APPLICATION FOR A RESIDENTIAL SITE IMPROVEMENT PERMIT/ CONSTRUCTION AUTHORIZATION FOR AN ON-SITE WASTEWATER SYSTEM, NEW WELL INSTALLATION, OR REPAIR OF EXISTING WELL

SOIL/SITE EVALUATION
for ON-SITE WASTEWATER SYSTEM

IMPROVEMENT PERMIT DENIAL

Re: Application for Improvement Permit for property located at 4509 WOODLAND AV , MINT HILL, NC 28227
Parcel No.: 13711270
Health Department File No.: SP26-097

PROPOSED PLOT PLAN

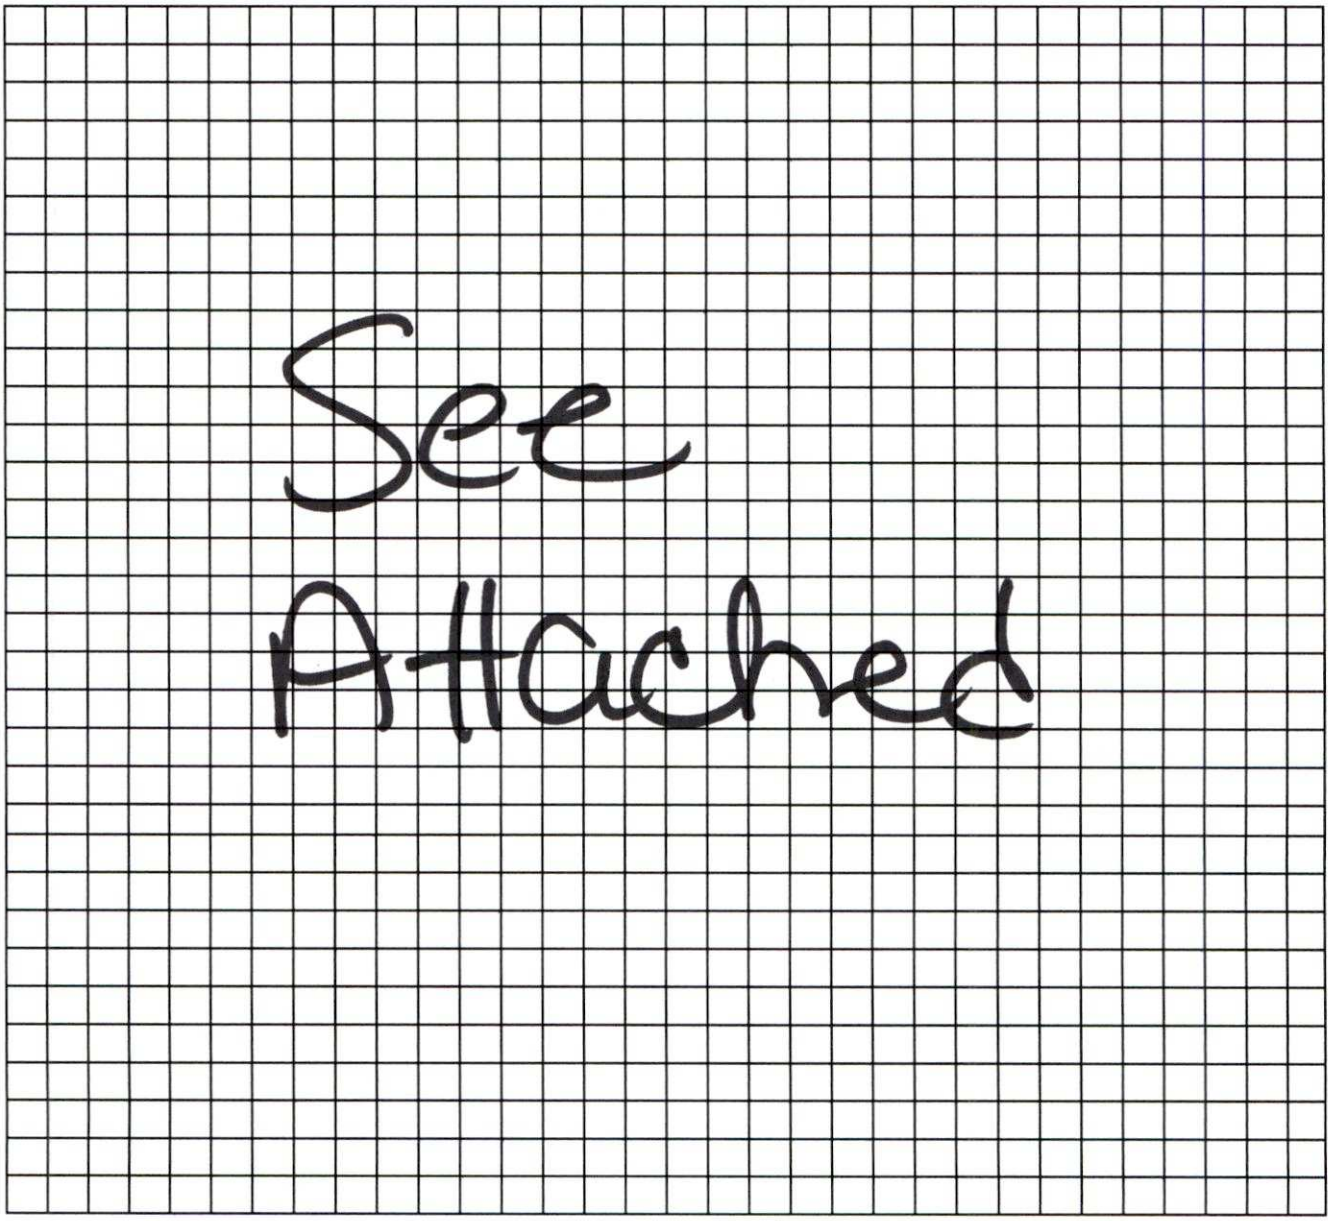
COMMENTS: There is insufficient space for a 5 BR SFR initial system and repair area with a design LTAR of 0.30.

Based on the criteria set out in 15A NCAC 18E .0501 through .0602, the evaluation indicated that the site is **UNSUITABLE** for an on-site wastewater system. Therefore, we must deny your request for an Improvement Permit. A copy of the site evaluation is enclosed. The site is unsuitable based on the following:

The site evaluation included consideration of possible site modifications, as well as use of all possible systems approved under 15A NCAC 18E. However, the Health Department has determined that none of the above options will overcome the severe conditions on this site. A possible option might be a system designed to dispose of sewage to another area of suitable soil such as off-site to additional property.

A site classified as UNSUITABLE may be classified as SUITABLE if written documentation is provided that meets the requirements of Rule .0509(b) or (c). A copy of this rule is enclosed. You may hire a consultant to assist you if you wish to try to develop a plan under which your site could be reclassified as SUITABLE.
